BCA ASSESSMENT REPORT

21 Oaks Avenue, Dee Why NSW

Project Number: 118613

Date: 29 February 2024

Location of the MSB on the Ground Floor

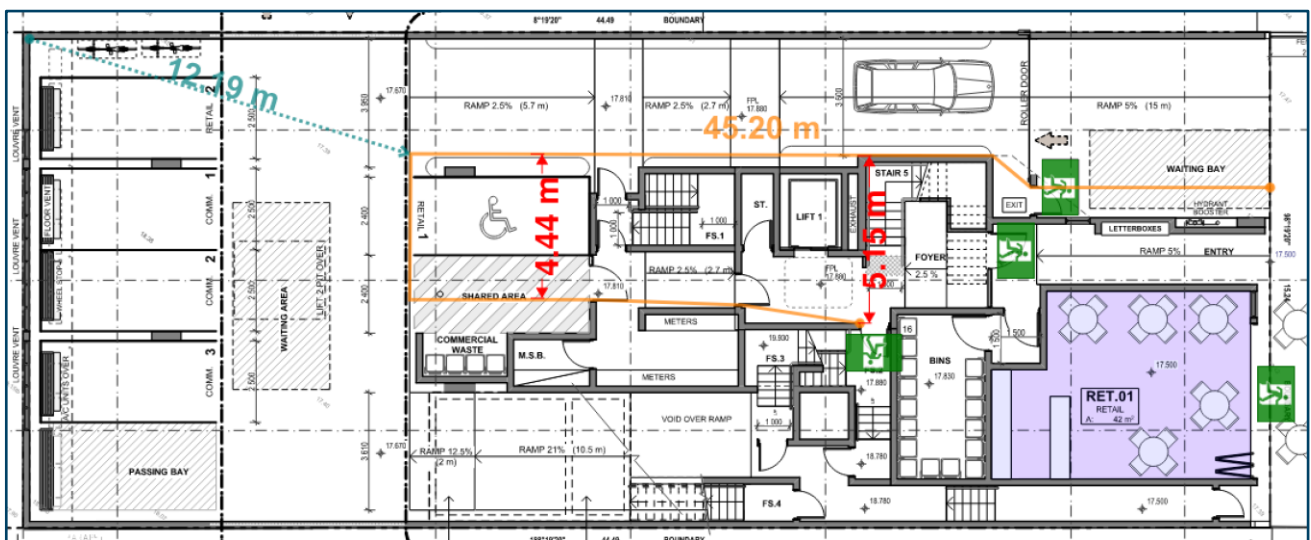
- + If the MSB on the Ground Floor is required to sustain emergency equipment operating in the emergency mode, BCA2022 Clause C3D14 requires that the main switchboard is—

- separated from any other part of the building by construction having an FRL of not less than **120/120/120**; and
 - has any doorway in that construction protected with a self-closing **-/120/30** fire door.

Convergence of alternative paths of travel on the Ground Floor

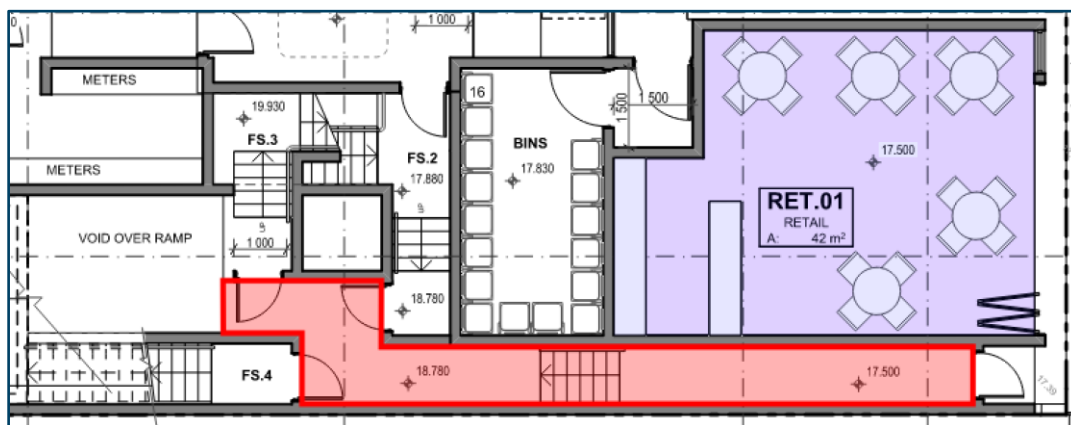
- + BCA2022 Clause D2D6(d) requires that alternative paths of travel must not converge such that they become less than **6 m** apart. Egress from carparking area on the Ground Floor relies on alternative paths of travel that are less than **6 m** apart. Early input from a Fire Safety Engineer is recommended to determine whether the proposed arrangement can be addressed as part of a Performance Solution.

Location of Ground Floor fire-isolated passageway

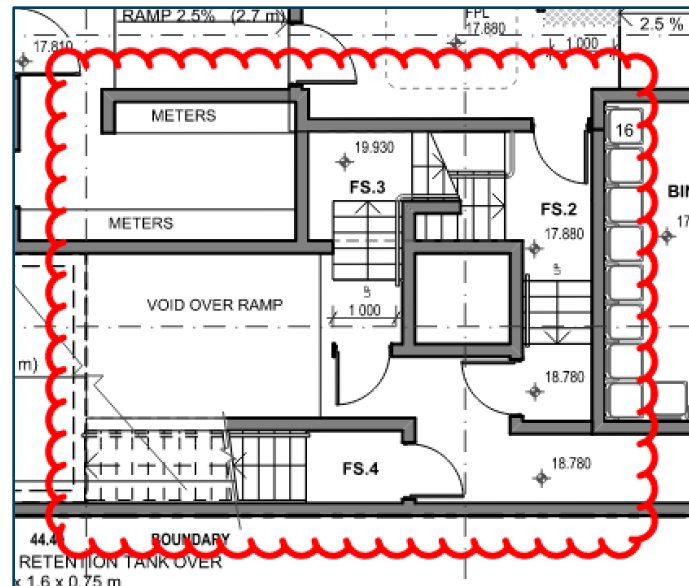
Fire-isolated stairways FS.2, FS.3 and FS.4 discharge into a shared fire-isolated passageway on the Ground Floor in lieu of their own fire-isolated passageways as required by BCA2022 Clause D2D12(2).

The Ground Floor fire-isolated passageway is served by three (3) access doorways. BCA2022 Clause D2D12(4) requires the passageway to be separated from fire-isolated stairways FS.2, FS.3 and FS.4 via a smoke lobby or provided with an air pressurisation system in accordance with AS 1668.1—2015. It is recommended that these provisions are omitted as part of a Performance Solution.

Location of FBBA

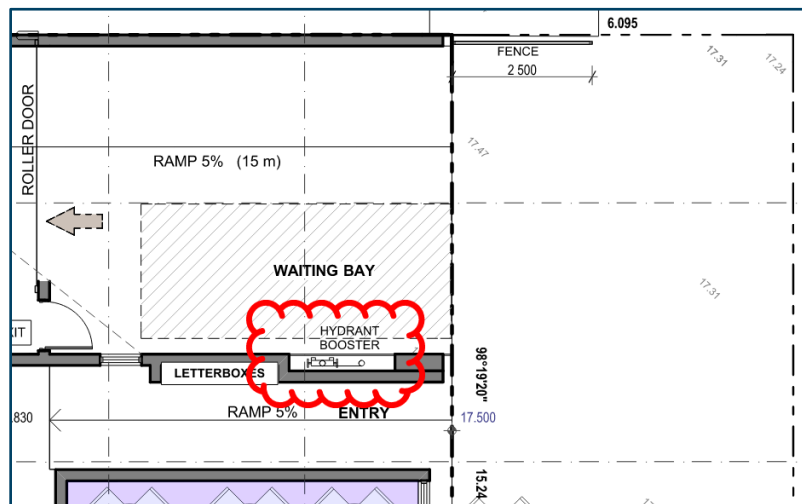
- + Clause 6.11.2(c)(ii)(B) of AS 2419.1—2021 requires that an internal pumphouse shall have a door leading directly to a fire-isolated passageway or stairway that is pressurised in accordance with AS/NZS 1668.1—2015. It is recommended that the Fire Safety Engineer omits the need to provide stair pressurisation to FS.2 as part of a Performance Solution.
- + Clause 7.3.3(c) of AS 2419.1—2021 requires that the fire brigade booster assembly (FBBA) fire hydrant outlets and fire brigade booster connection inlets face the hardstand. Currently, the FBBA on the Ground Floor is perpendicular to Oaks Avenue. The Fire Safety Engineer is to address the current arrangement as part of a Performance Solution.
